**CITY OF CARLTON
PLANNING COMMISSION AGENDA
MONDAY, DECEMBER 11, 2023, 6:00 P.M.
VIA ZOOM AND 945 WEST GRANT STREET**

To: Members of the Planning Commission
From: Scott Whyte, Contract Planner for the City of Carlton
Subject: Continued Public Hearing for 2nd Street Preliminary Subdivision, SUB 2023-02
Date: December 4, 2023, for the December 11, 2023, meeting

To: **City of Carlton Planning Commission**
 From: **Todd E. Mobley, PE**
 Date: **November 21, 2023**
 Subject: **SUB 2023-02; 2nd Street Subdivision – E Taylor Street Alignment Options**

S 2ND STREET SUBDIVISION Exhibit B-4

**CONCEPTUAL E TAYLOR STREET ALIGNMENT 3
S 2ND STREET SUBDIVISION
CARLTON, OREGON**

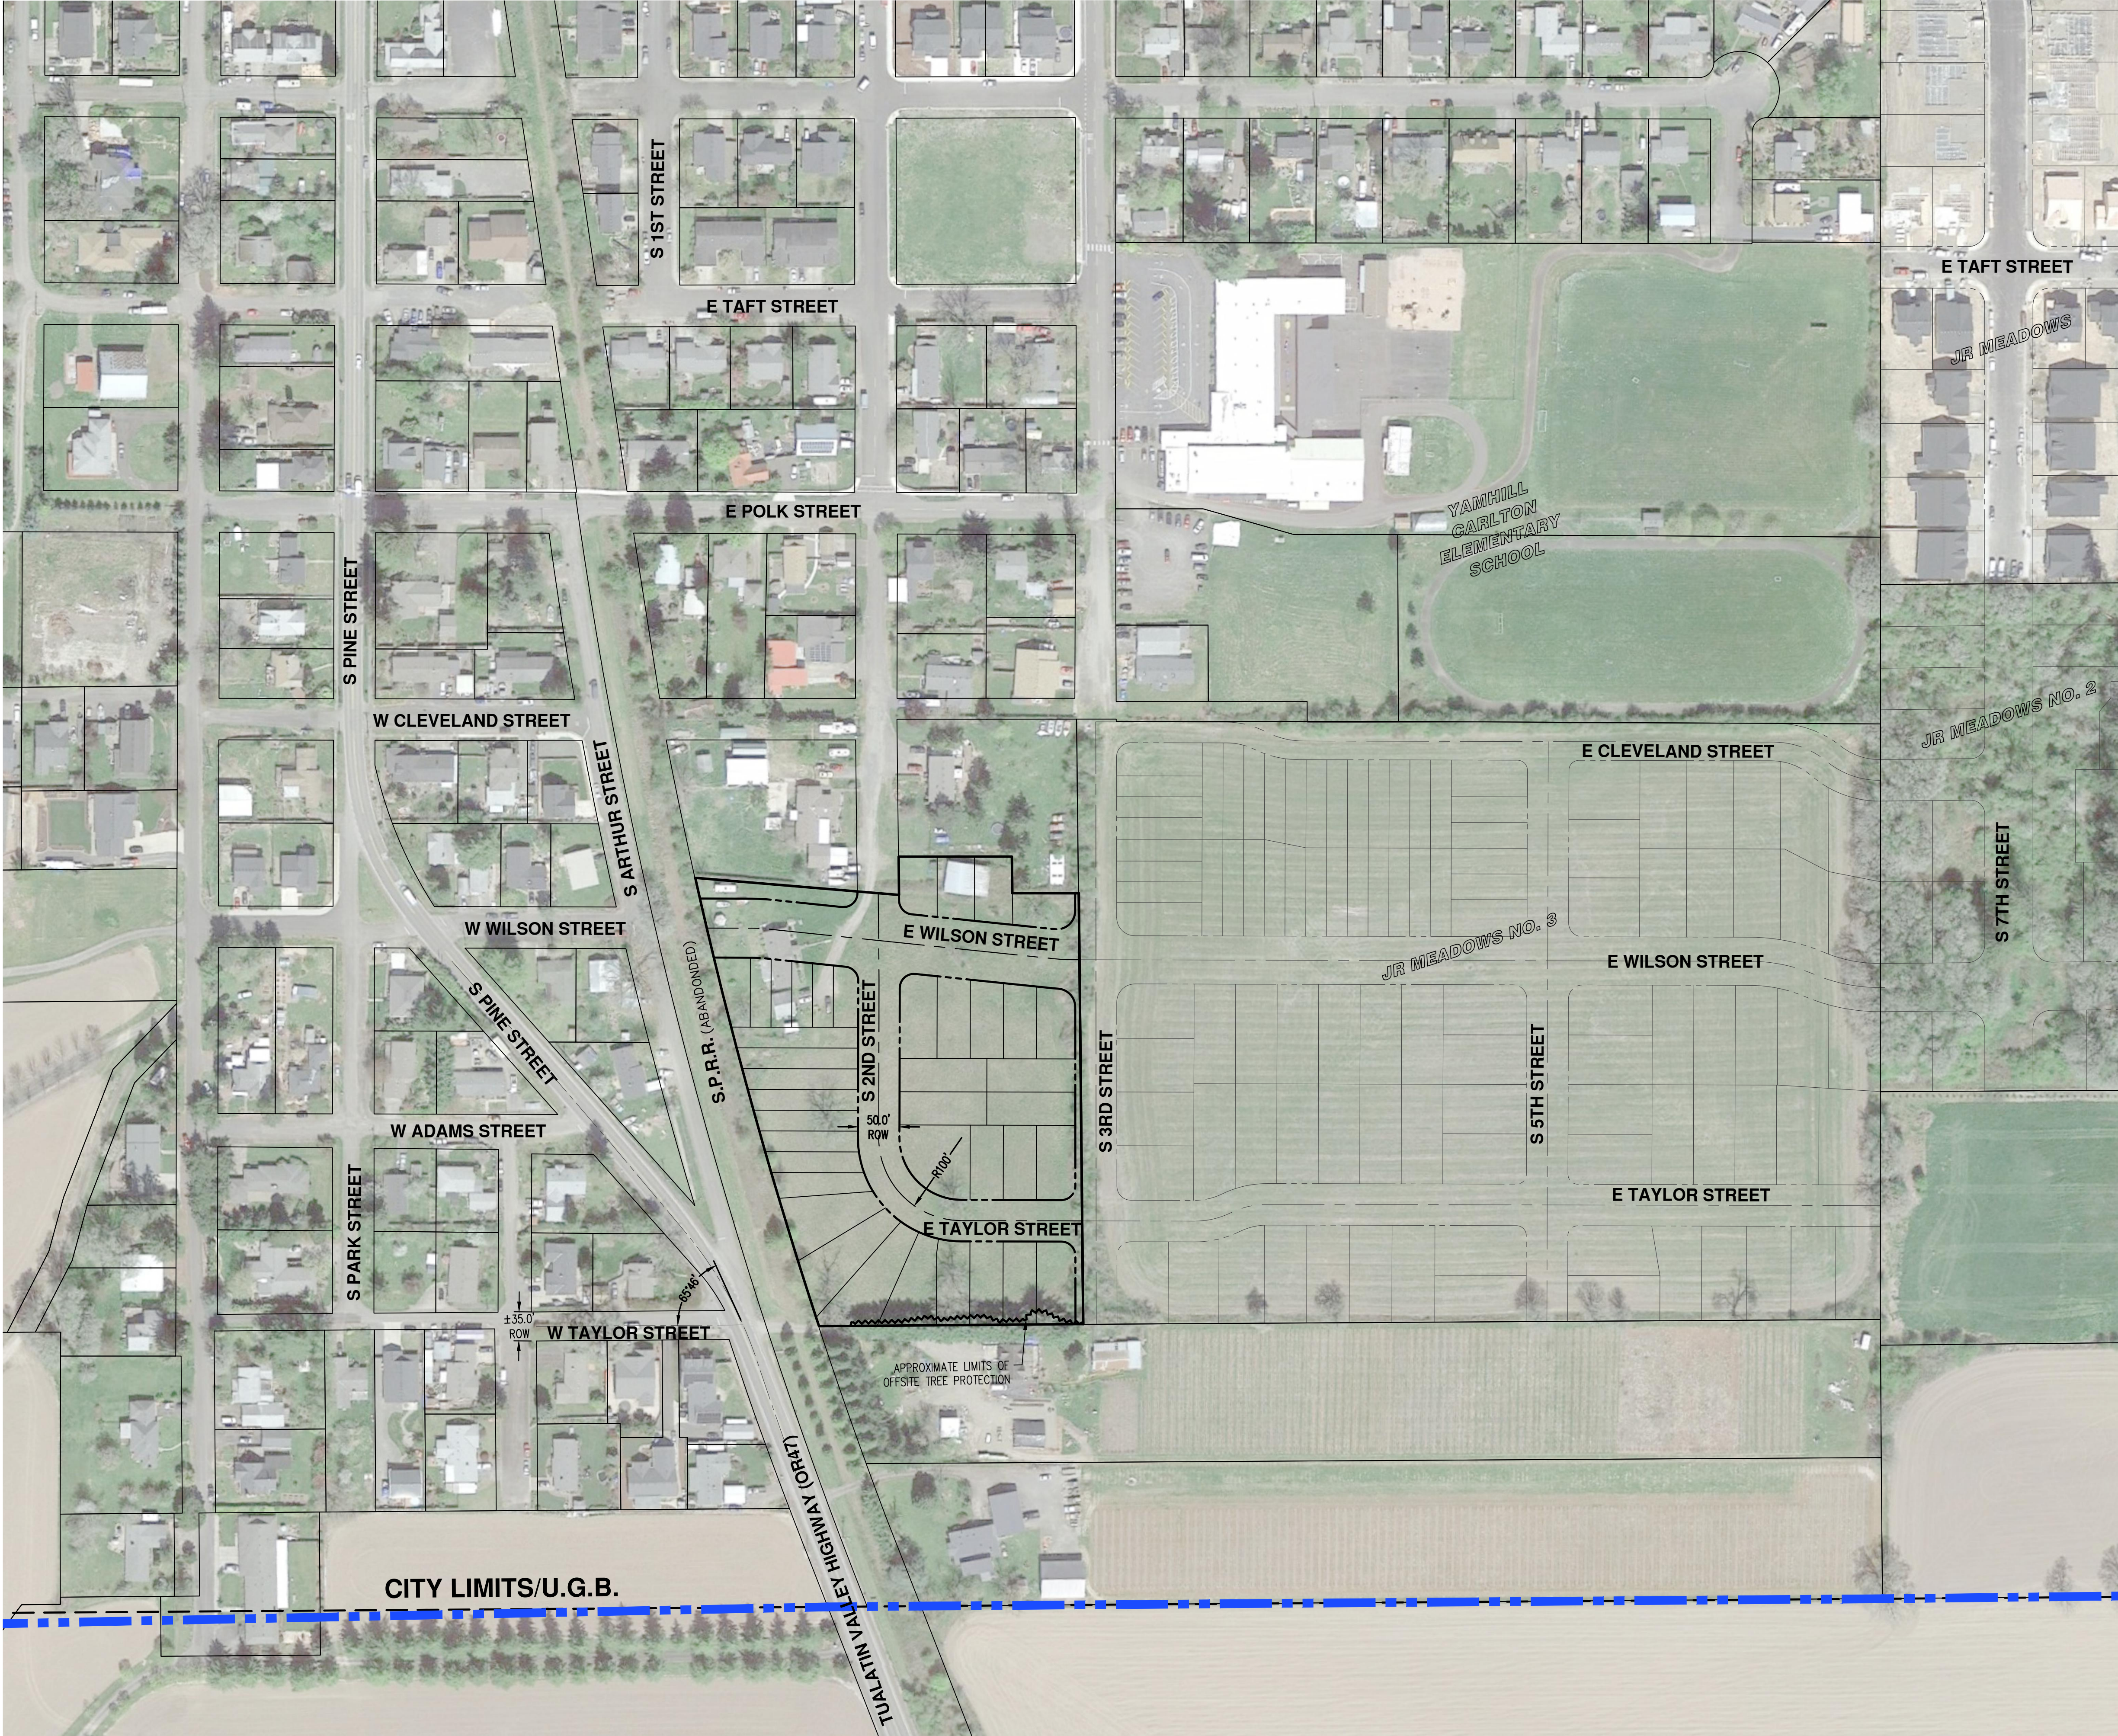
Supplemental Findings – Staff Review of **Alignment Option 3**: In review of Alignment Option 3 (no extension of Taylor to the western boundary) staff finds the standard in C only applicable to alignment. If no street extension / stub of Taylor is proposed to the west (as Alignment Option 3 shows) the standard in C does not apply. However, staff finds the standard in D (Future Extension of Streets) to remain applicable and is not met in review of Option 3.

Supplemental Finding – Standard in D is clear and objective and does not support **Option 3**: Staff finds the standard in D of 17.64.030 to be clear and objective for the following reasons:

Alignment Option 3 provides some extension of E. Taylor Street through the site but does not fully extend the street to a point that enables future connection consistent with the Future Street Plan. If the city approves Option 3 and later decides that such connection is desired, two lots / dwellings shown to applicant’s revised plan (Exhibit B-4) would need to be purchased.

Supplemental Finding - lack of Map Amendment application to support Alignment **Option 3**: If no stub of Taylor Street is provided to the west (as depicted in Alignment Option 3) staff finds a TSP map amendment application to be warranted for Option 3 as follows:
